# Origination Form

## Proposed Revisions to a Standard Plans Index

<b>Originator:</b>	Stutts, Dylan	<b>Index Number:</b>	700-010
<b>Date:</b>	6/27/2024	<b>Sheet Number(s):</b>	7
<b>E-mail:</b>	Dylan.Stutts@dot.state.fl.us	<b>Index Title:</b>	SINGLE COLUMN GROUND SIGNS

WIND BEAM CONNECTION FOR FLIP DOWN SIGN

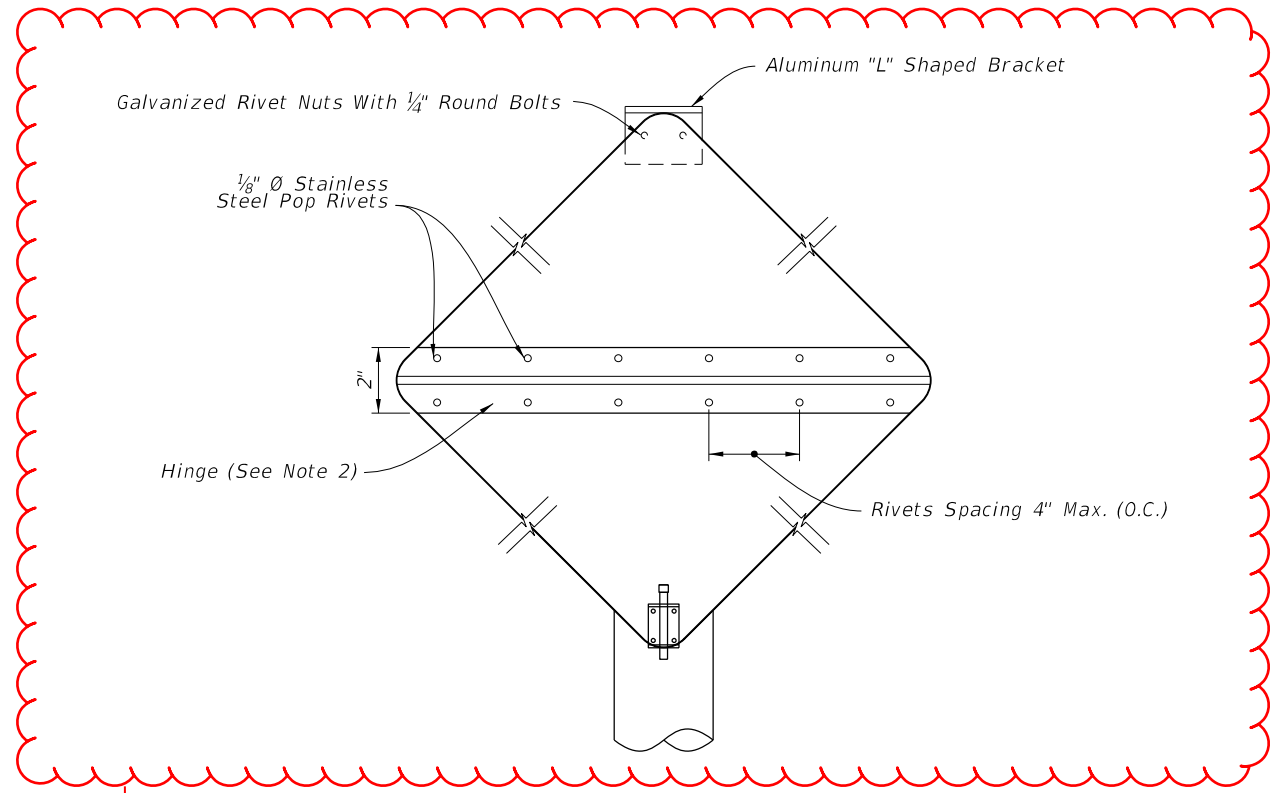
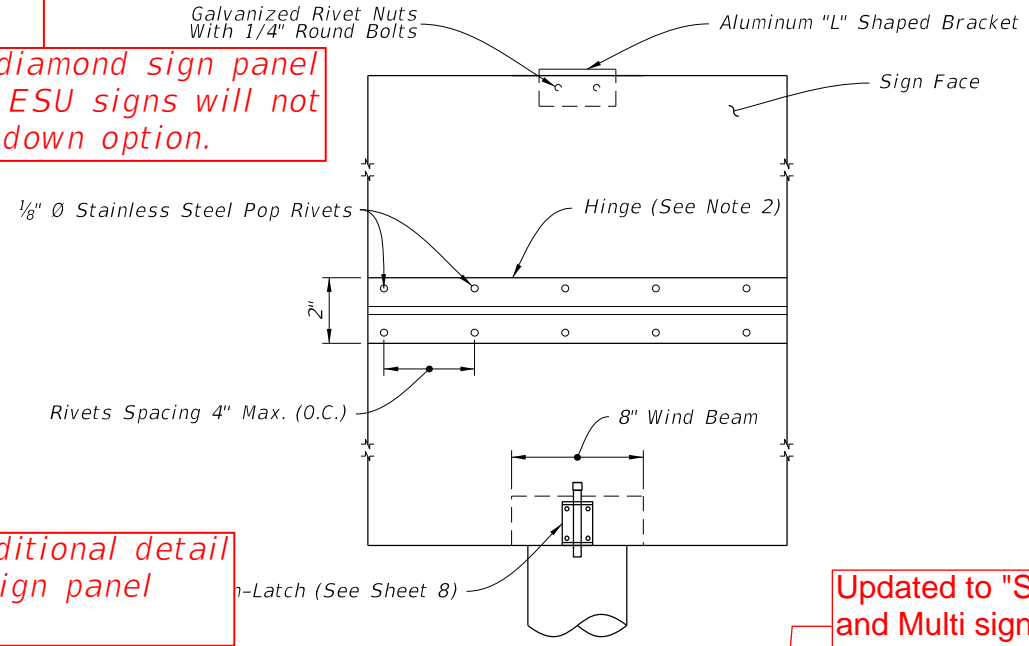
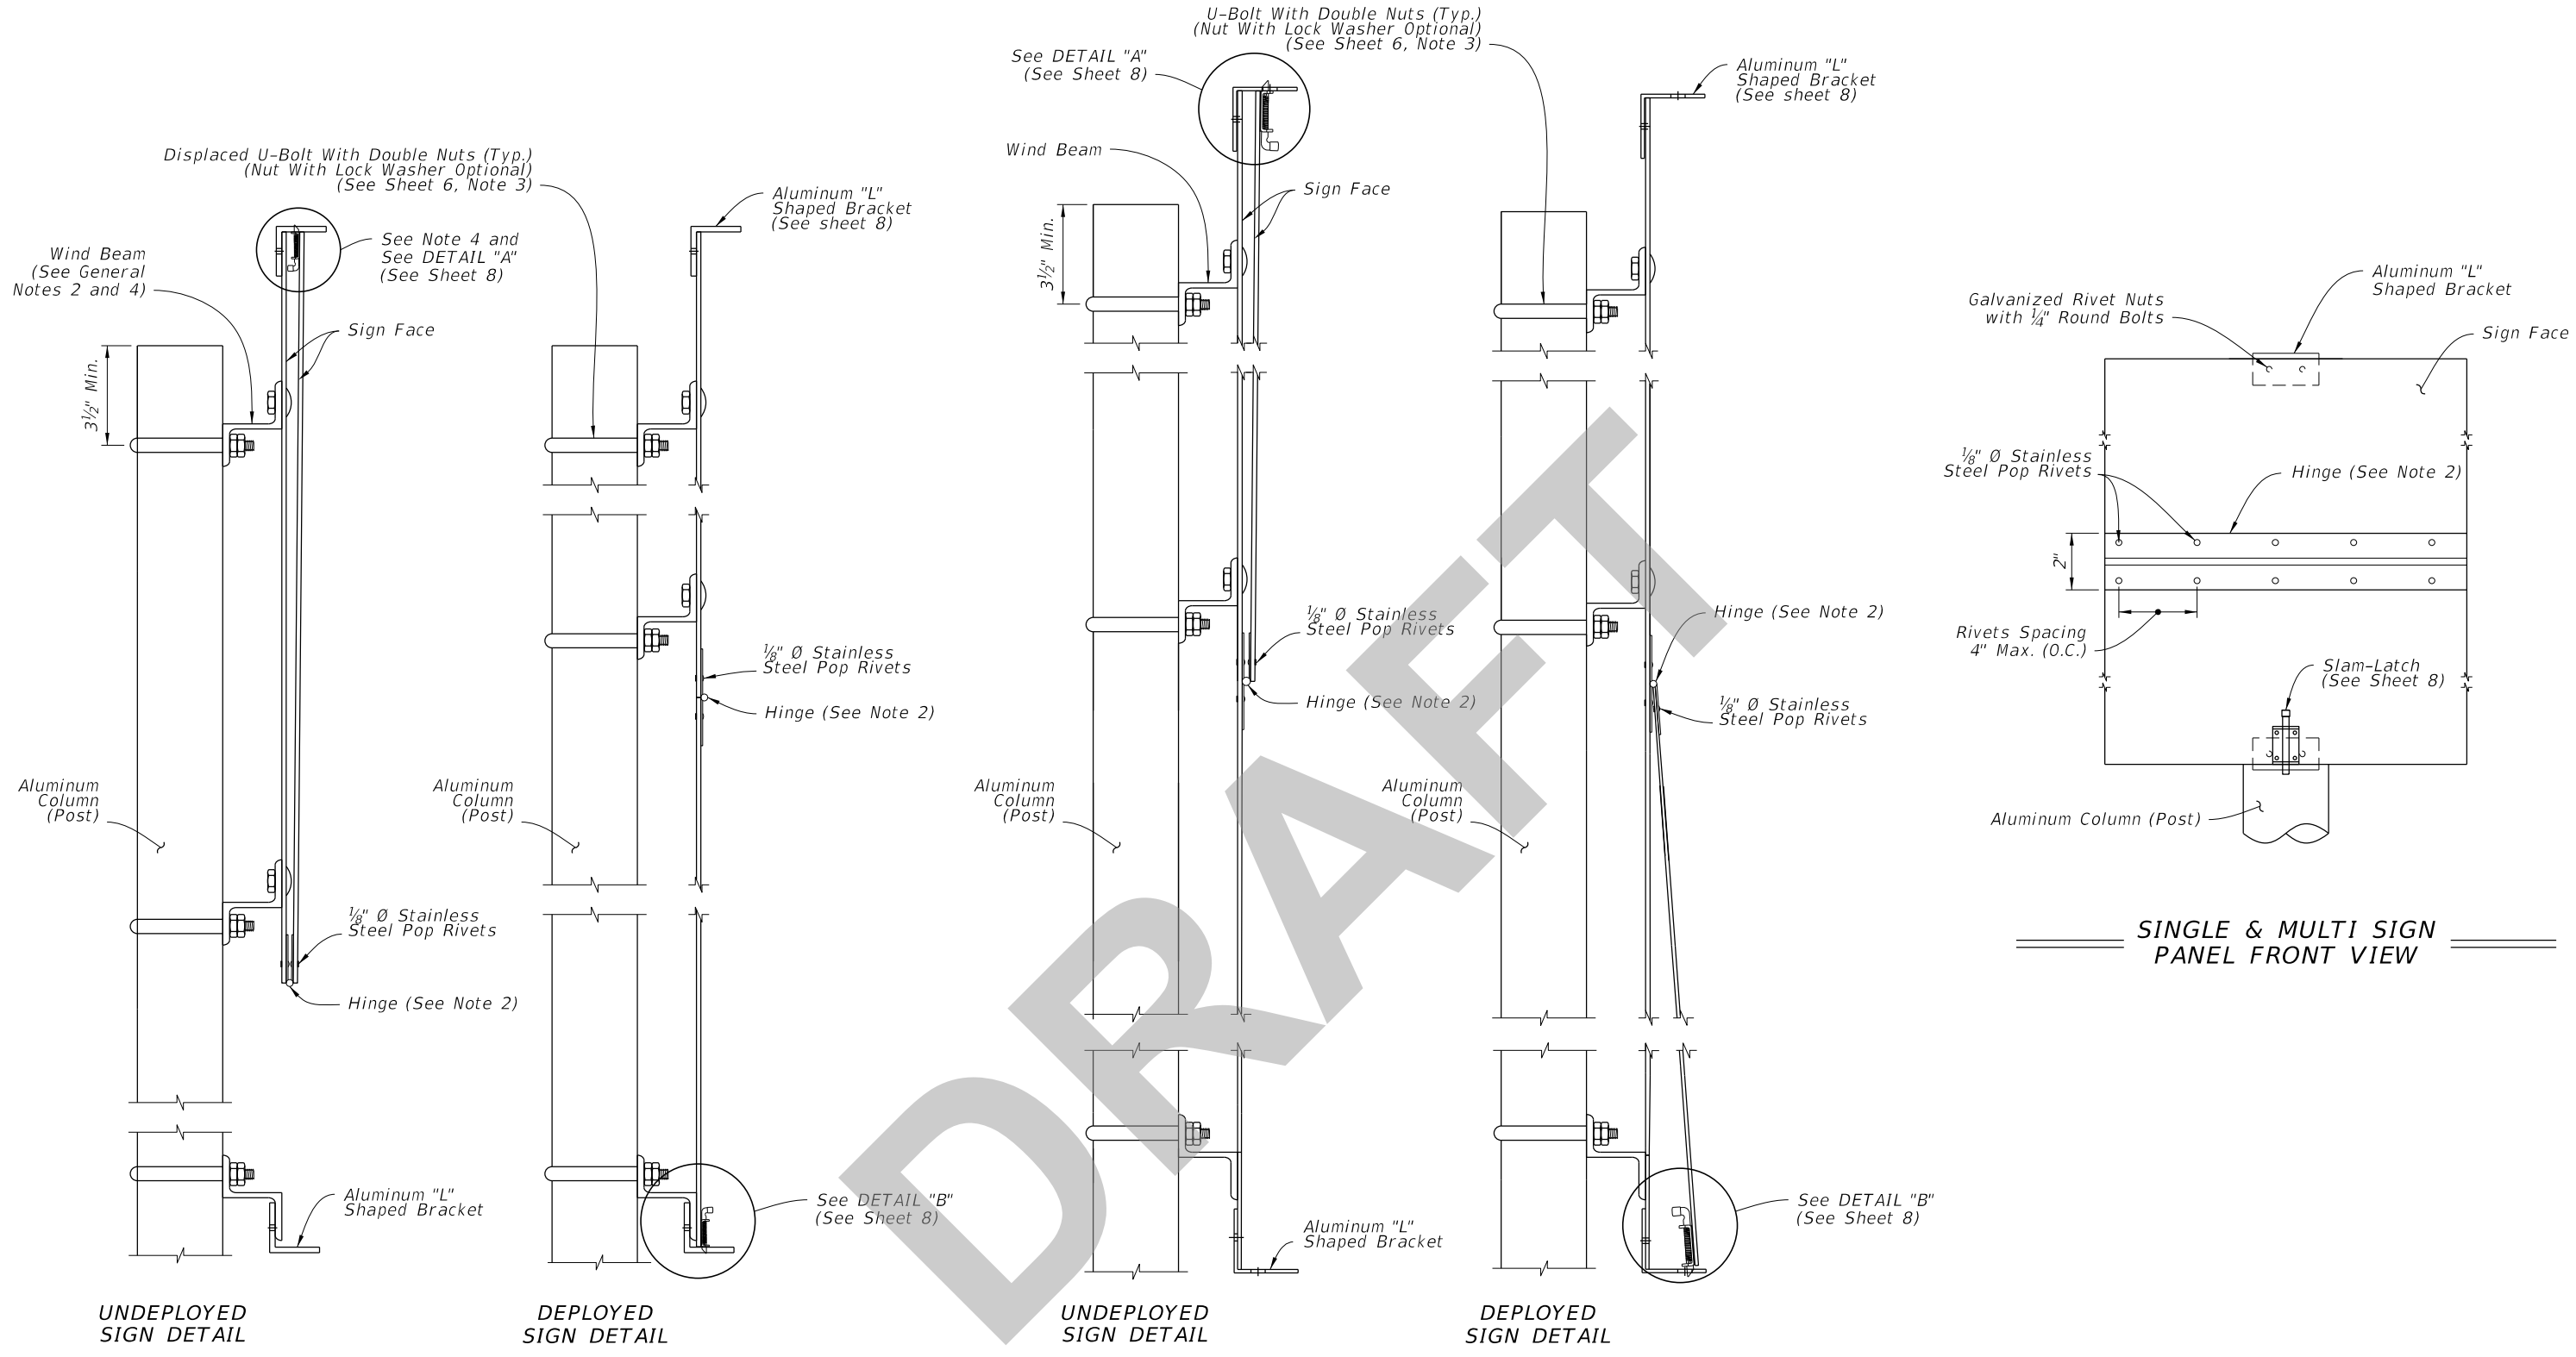
Sheet 7: Updated the flip sign to allow for multiple sign panels; Removed the diamond sign panel; Updated Note 1 to "Install sign with the ESU sign panel in the undeployed (up) position."; Added Note 5 "Multi sign panel assembly only use one of the following approved signs: FTP 43-06, FTP 47-06, and FTP 66-21."; Added ESU to sheet title

Removed the diamond sign panel as temporary ESU signs will not have the flip down option.

Updated to "Single and Multi sign panel front view"

Added additional detail for two sign panel option

Added Note 5: Multi sign panel assembly only use one of the following approved signs: FTP 43-06, FTP 47-06, and FTP 66-21.

Added ESU between "For" and "Flip"

Changed language "Install sign with ESU sign panel in the undeployed (up) position."
